ISSUE: Permit to Demolish/Capsulate (partial) and Certificate of Appropriateness

APPLICANT: Leslie and William Golden

426 South Lee Street

STAFF RECOMMENDATION

Figure 1 - rear/east elevation view from Potomac View Park

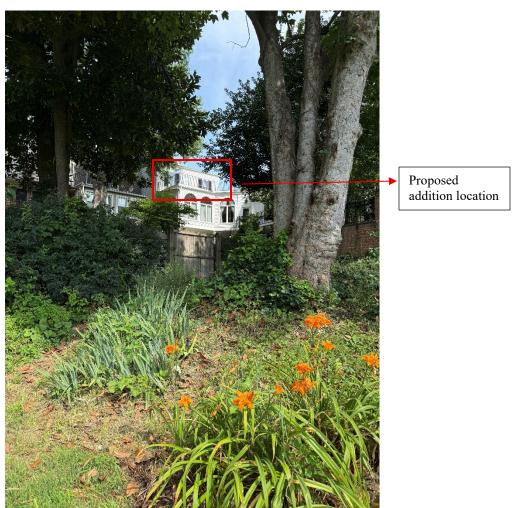
The subject property sits on the east side of the 400 Block of South Lee Street. There is no alley running adjacent to the property; however, its rear/east elevation faces Potomac View Park and is visible from the public park (Figure 1).

In the opinion of staff, none of the criteria for demolition and capsulation are met. Most of the demolition/capsulation will take place in the rear and will be minimally visible from the Potomac View Park. The capsulation does not remove any portion of the building containing character-defining features of uncommon design or historic merit and does not compromise the integrity of the main block. As noted above, this portion of the building was constructed between 1988 and 1989. Staff therefore has no objection to the demolition/capsulation and recommends **approval** of the Permit to Demolish/Capsulate, as submitted.

REAR ELEVATION W/ADDITION

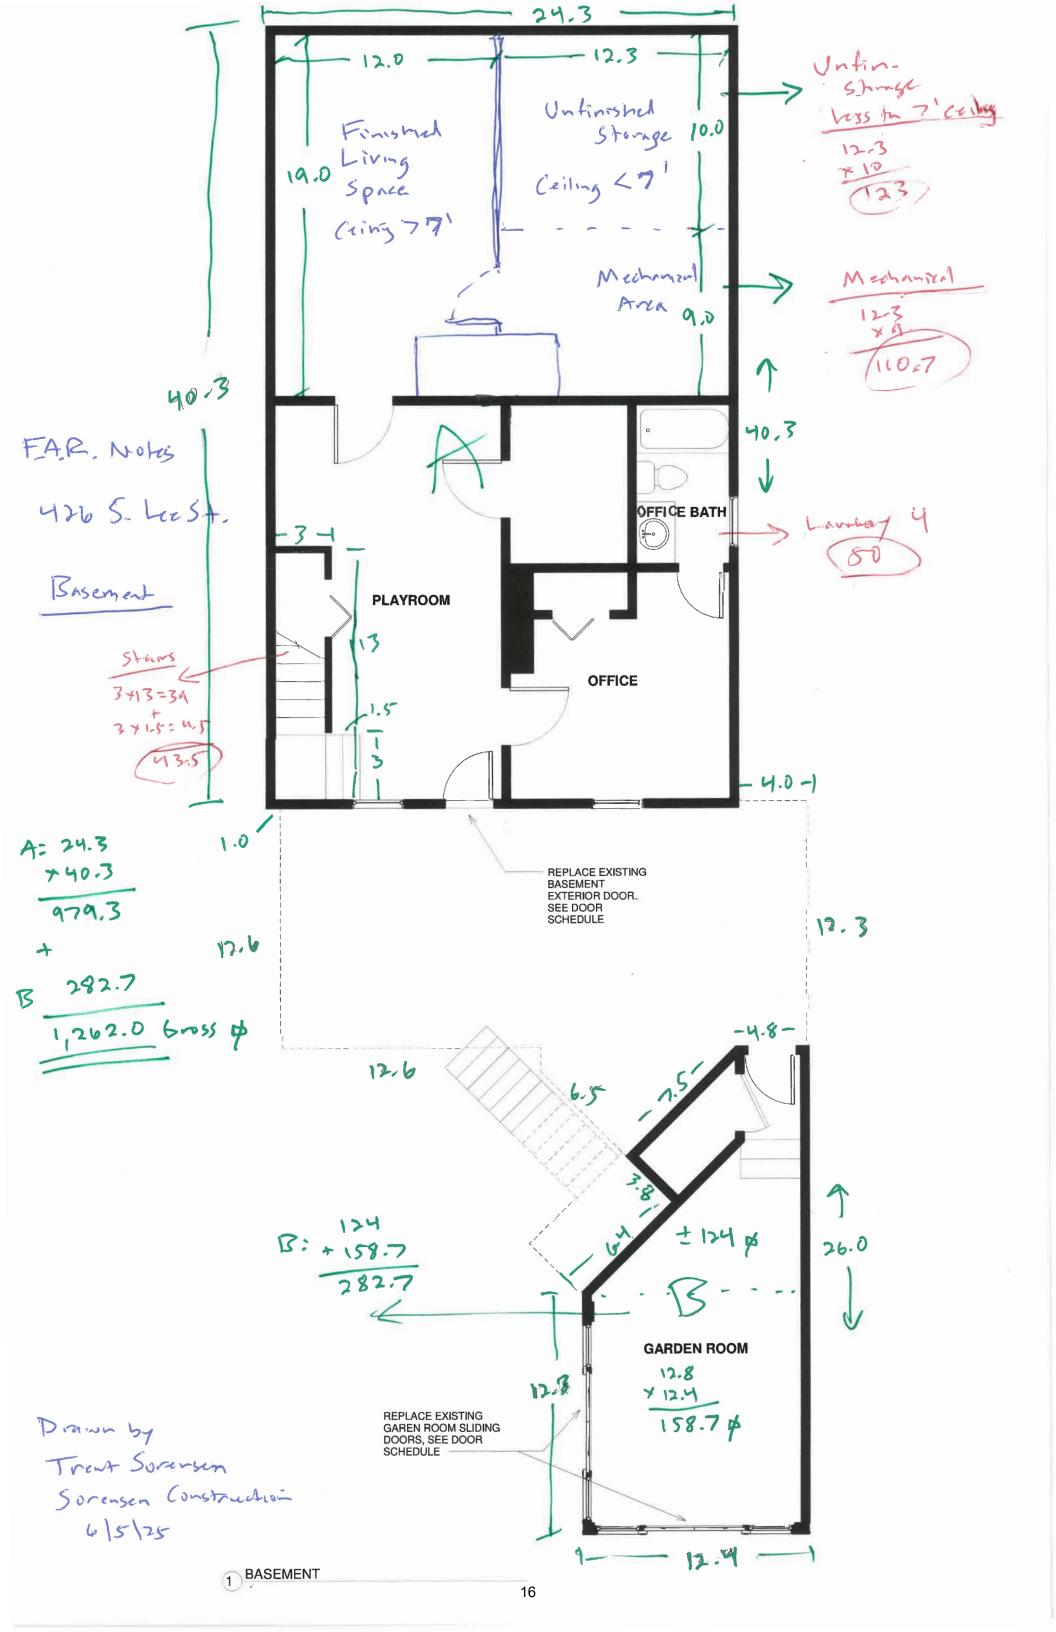
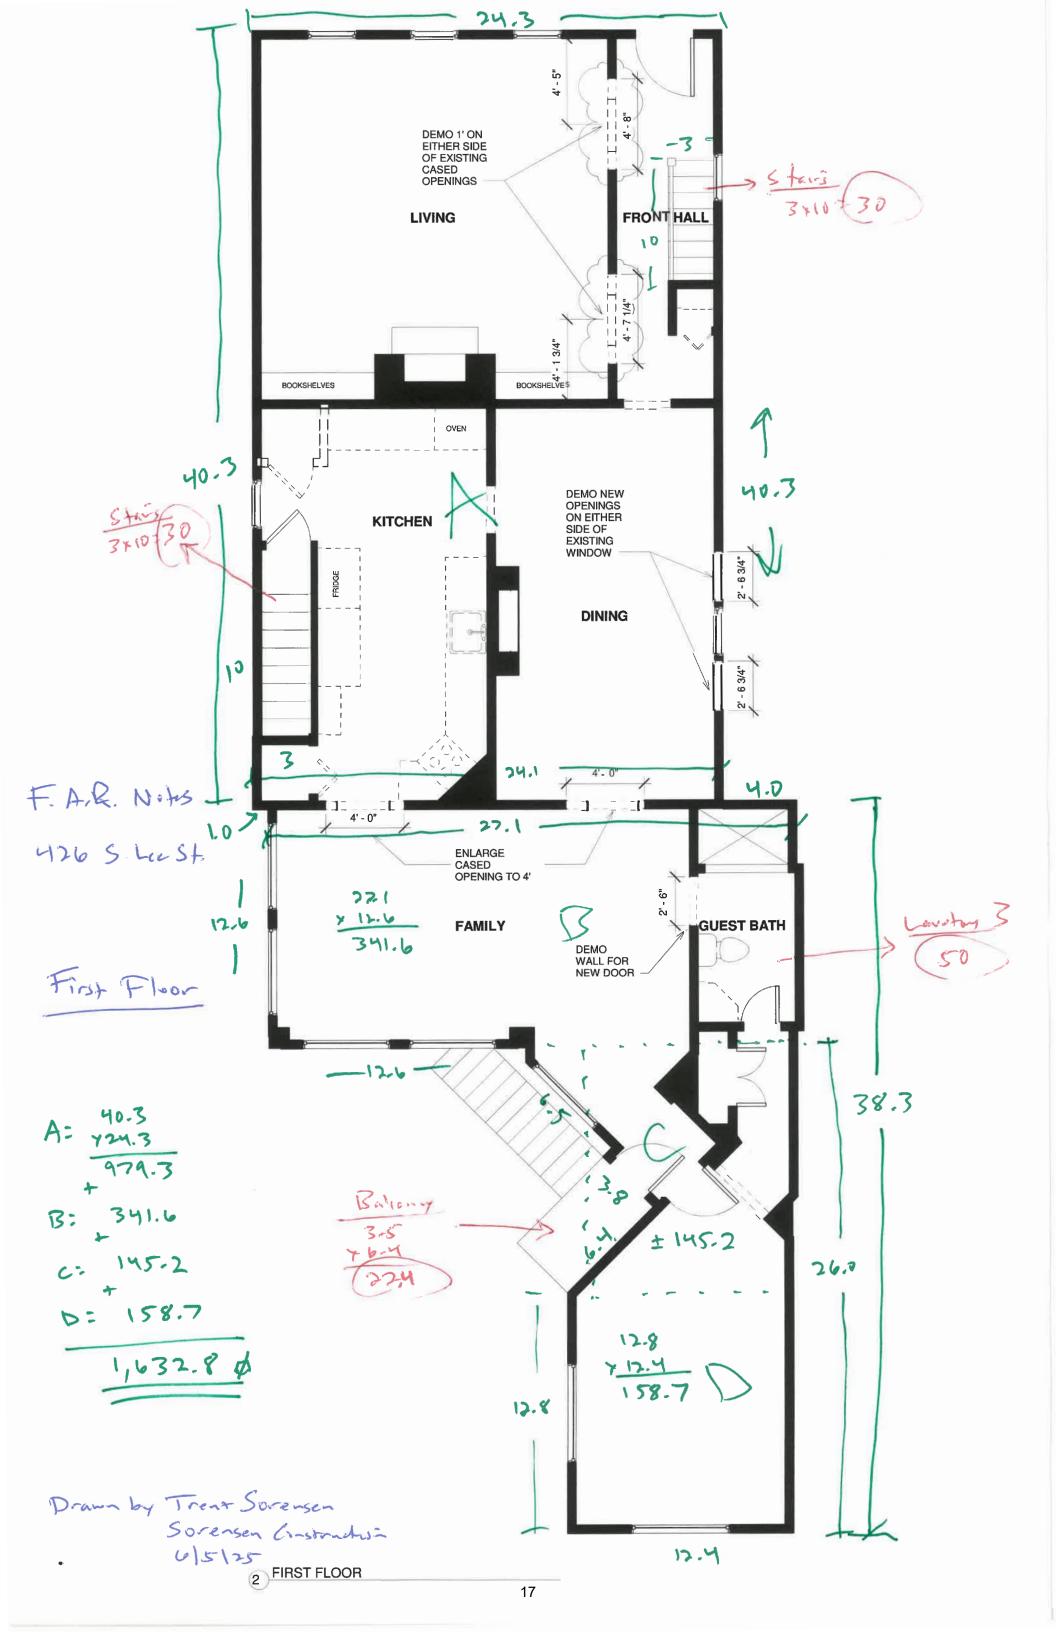
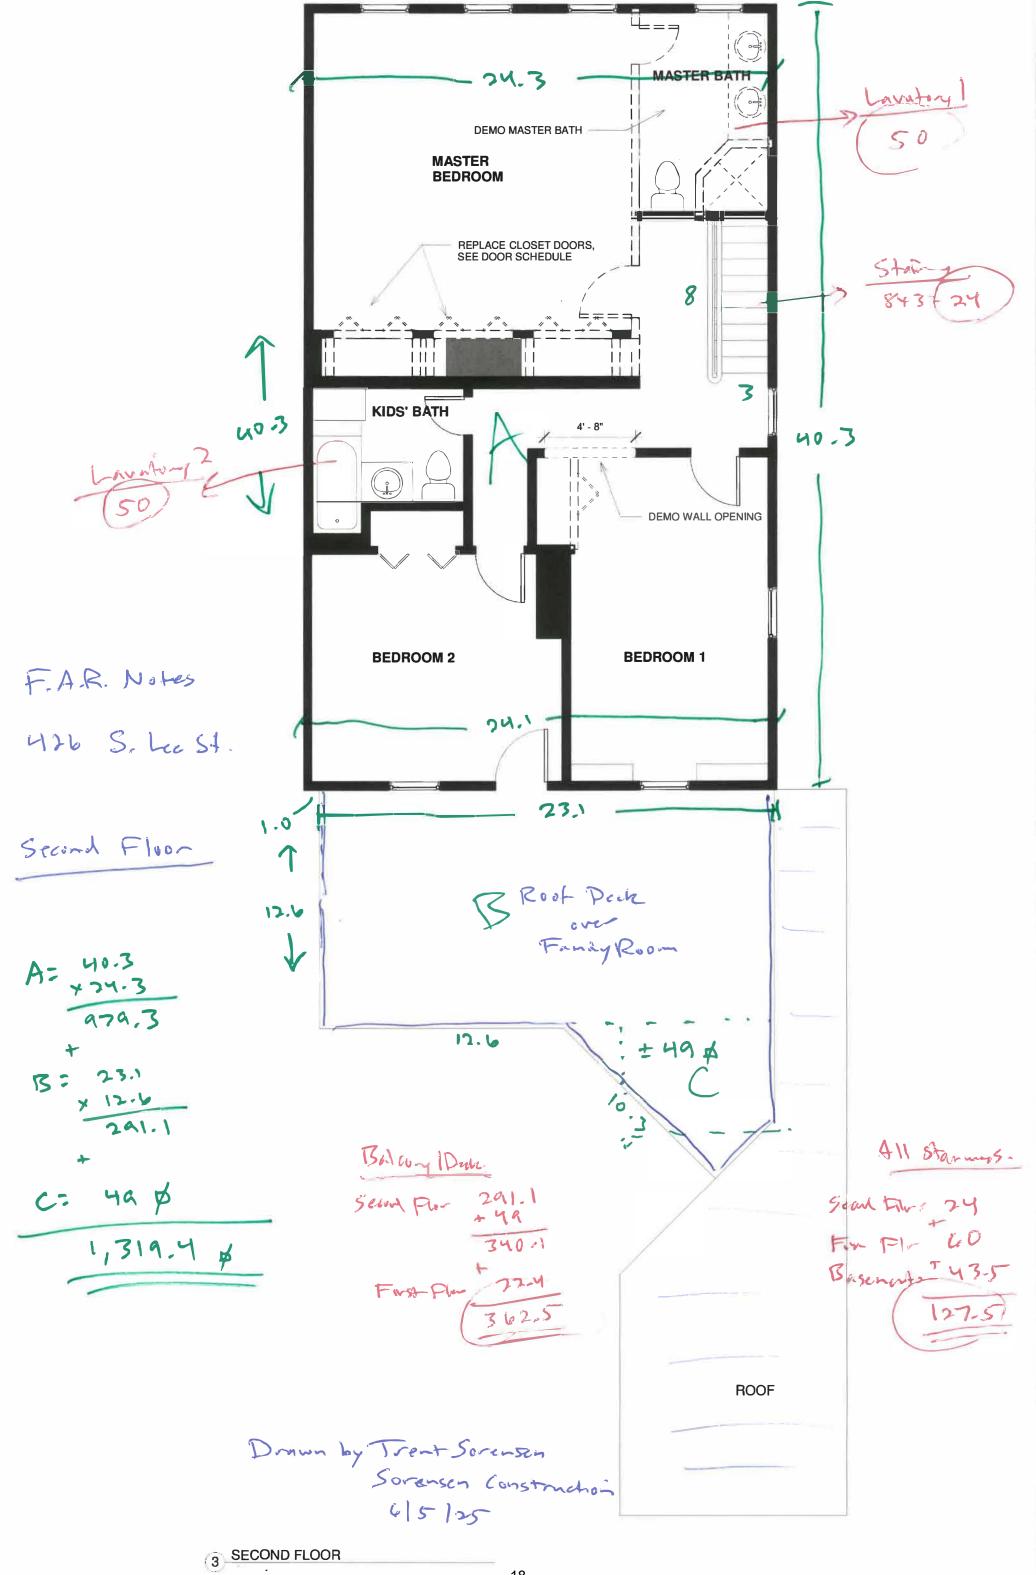
The applicant is proposing to construct a one-story addition 20.9' x 7.5 at the rear/east elevation onto the existing roof deck above the family room. The addition will have a flat roof, clad with composite lap siding to match the existing. Two doors will give access to the remaining portion of the roof deck. Door specs were not provided.

The *Design Guidelines* state that: "The design of an addition should respect the heritage of the historic building to which it is attached as well as adjacent buildings. The Boards generally prefer addition designs that are respectful of the existing structure, and which seek to be background statements, or which echo the design elements of the existing structure." Furthermore, "...the Boards seek to promote compatible development that is, at once, both responsive to the needs and tastes of the late 20th [21st] century while still being compatible with the historic character of the districts." In evaluating the compatibility of new construction, the Board generally focuses on height, scale, mass and architectural character, while also reviewing material selection, fenestration and architectural detailing on a more micro level. The proposed addition is small and blends well with the existing building, it does not diminish or detract from the historic character of the main historic building or the historic district. Therefore, staff recommends approval of the project on the condition that the two doors on the new addition comply with the BAR policy.

Staff recommends approval of the Permit to Demolish/Capsulate and Certificate of Appropriateness for alterations and addition with the condition that the proposed addition doors comply with the BAR policy.
